## DOCUMENT CHANGE REQUEST

DCR number 382 Changes required for: General

Title: Transistors Low Power NPN, based on types 2N3498 thru 2N3501

Number: 5201/013

### 1.5 MAXIMUM RATINGS

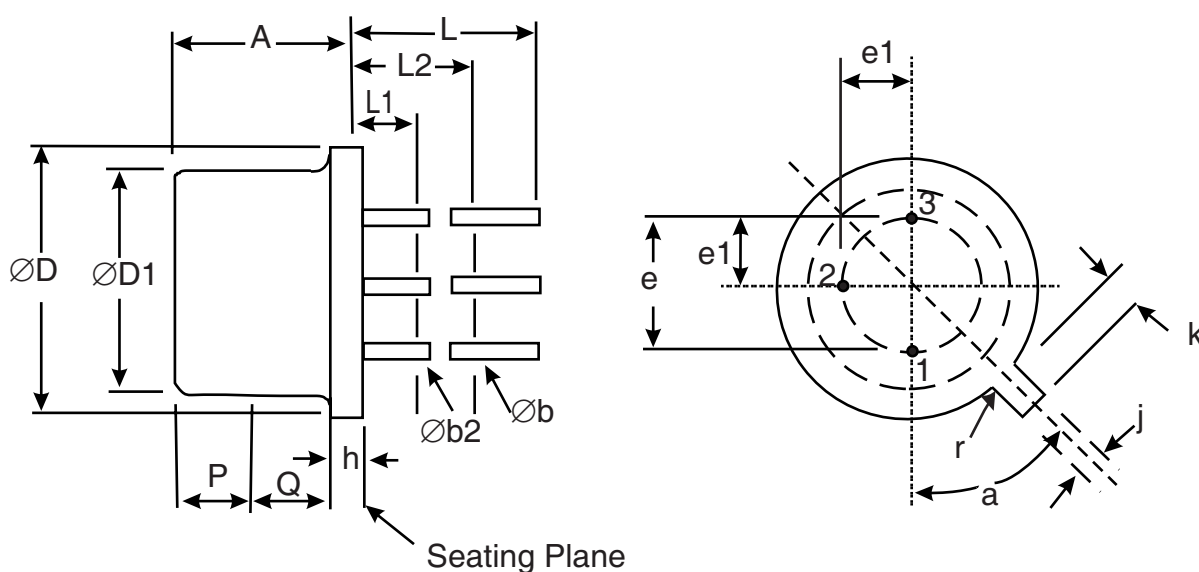
1. Rewording and restructuring of various sections and paragraphs of the specification, plus other editorial changes based on the layout and editorial content of other Detail Specifications already converted to ESCC format.
2. Deletion of redundant paragraphs and information such as Mechanical Requirements.
3. Para. 1.7 High Temperature Test Precautions requirements moved to be a note (Note 2) to the Maximum Ratings table.
4. Deletion of obsolete Variants 03 to 12 from the available range (not supported by Semelab).
5. Maximum Ratings table: Remark "Over entire operating temperature range" added for Collector-Base, Collector-Emitter and Emitter-Base voltages.
6. Figure 1 Parameter Derating Information moved to be a note to the Maximum Ratings table.

- For  $T_{amb}$  or  $T_{case} > +25^{\circ}\text{C}$ , derate linearly to 0W at  $+200^{\circ}\text{C}$ .
- For Variants with tin-lead plating or hot solder dip lead finish all testing performed at  $T_{amb} > +125^{\circ}\text{C}$  shall be carried out in a 100% inert atmosphere.
- Duration 10 seconds maximum at a distance of not less than 1.5mm from the device body and the same lead shall not be resoldered until 3 minutes have elapsed.

## 1.6 PHYSICAL DIMENSIONS AND TERMINAL IDENTIFICATION

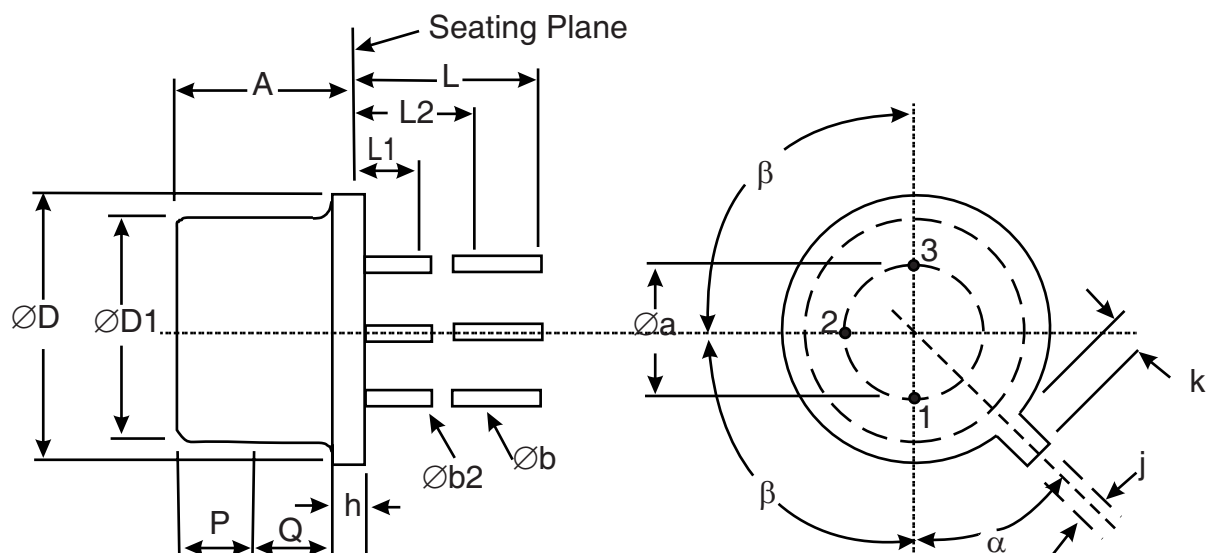
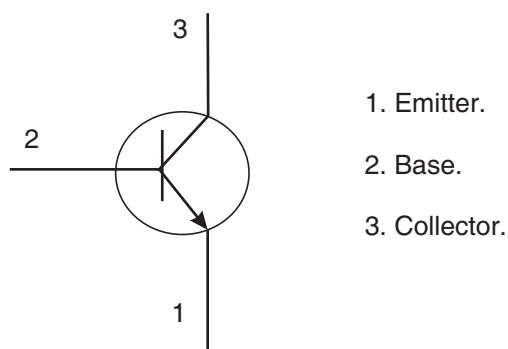
8. Figure 2 re-named "Physical Dimensions and Terminal Identification"; Figures 2(a) and 2(b) amended (standardisation of the TO-5 and TO-39 packages).

VOLTAGE WAVEFORMS

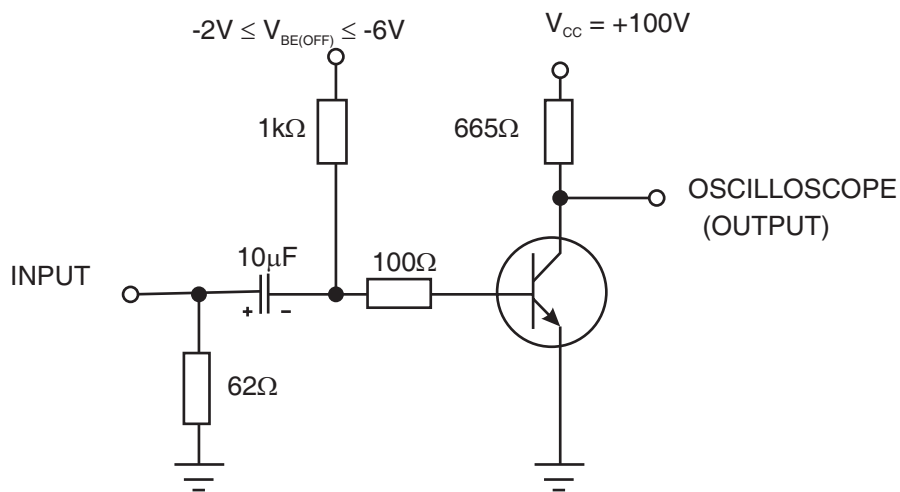
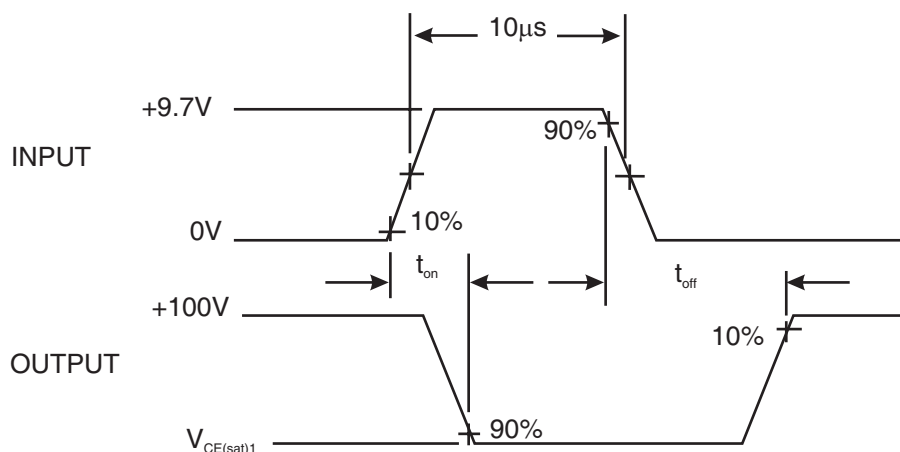
22. Figure 4 amended (and Voltage Waveforms added) and moved to be a note (Note 3) to Room Temperature Electrical Measurements.

1. Pulsed measurement: Pulse Width  $\leq 300\mu s$ , Duty Cycle  $\leq 2\%$ .
2. For AC characteristics read and record measurements shall be performed on a sample of 32 components with 0 failures allowed. Alternatively a 100% inspection may be performed.
3.  $t_{on}$  and  $t_{off}$  shall be measured using the following test circuit. The input waveforms for  $t_{on}$  and  $t_{off}$  shall be supplied by a pulse generator with the following characteristics:  $Z_{OUT}=50\Omega$ ,  $t_r = t_f \leq 20ns$ , Pulse Width  $\geq 10\mu s$ , Duty Cycle  $\leq 2\%$ . The output waveforms shall be monitored on an oscilloscope
